RECEIPT DATE: 4-3-23 **ONSITE SEWAGE DISPOSAL SYSTEM** P 574072
 APPROVAL DATE: _____ **PERMIT: CONSTRUCTION** A _____
 PROPERTY ADDRESS: 12363 Pleasant View Drive
 SUBDIVISION: Fulton Manor LOT: 27 TAX ID: 5418178
 CONTRACTOR: Hofffields Equipment EMAIL: Ken@hofffieldsequipment.com
 CONTRACTOR ADDRESS: P.O. Box 519 Annapolis Junction MD 20701 PHONE: 301-490-4289
 PROPERTY OWNER: John Sessler EMAIL: _____
 OWNER ADDRESS: 12363 Pleasant View Drive PHONE: 410-980-9868

LOT 27, FULTON MANOR
ON-SITE SEWAGE DISPOSAL SYSTEM PLAN
12363 PLEASANT VIEW DRIVE
FULTON, MD 21029
TAX#: 418178, SUB: 2204

From: Silvast, Zackary <zsilvast@howardcountymd.gov>
Sent: Thursday, September 8, 2022 6:26 PM
To: Brian Collins <Brian.Collins@kci.com>
Cc: Martin, Sharhonda <smmartin@howardcountymd.gov>
Subject: Regarding 12363 Pleasant View Drive (PC & OSDS plans)

NOTE: THE PURPOSE OF THIS REVISION IS TO PROVIDE SPACE IN ORDER TO FIT A PROPOSED POOL AND HARDSCAPED SPACE ON THE PROPERTY.

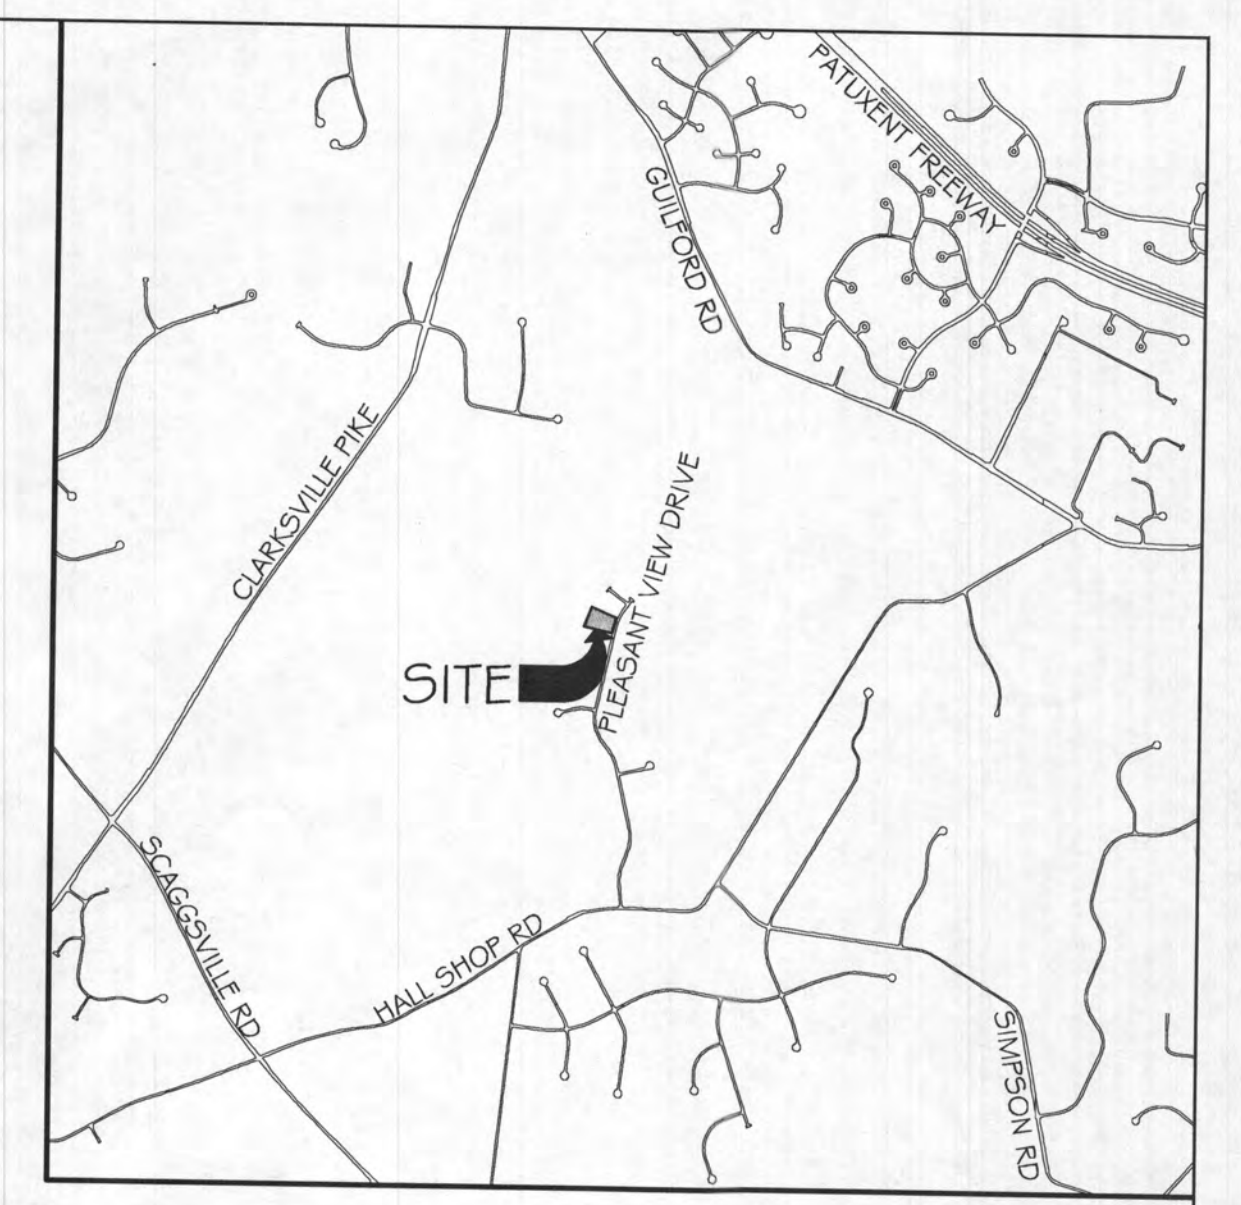
1. I let it go on the perc cert. to speed up the process and since the perc cert. had already gained approval back in April as is, but the wells should have been shown with the well tag numbers on them also.

- a. It would have been appropriate to include those tag numbers and with a lighter font than the subject property.
 - b. I do want the tag numbers included on the OSDS plan.

2. The 1st replacement system should have been designed with 1' effective depth.
 - A. I have attached Bricker's original spec sheet (see attached above).

- B. This may change some of the configuration as that 1st replacement system will now be even larger.
 - a. It is important to note that the lines should stay as linear as possible and on contour as much as possible.

- b. No crazy configurations to squeeze everything in. (not saying you would, but as a point to be made)
3. I am confused by note number 11. I think all three of these systems would be able to achieve gravity distribution.

- A. If one system needs to be an LPD, those details need to be provided on the OSDS even if it is for a "future repair."
 - B. Now would be the time to do that LPD design.

- C. You would also want to include "the future pump pit location." And show both of those "tank details."
 - a. Pump tank should be lighter and dotted on the site plan since it is for future use.
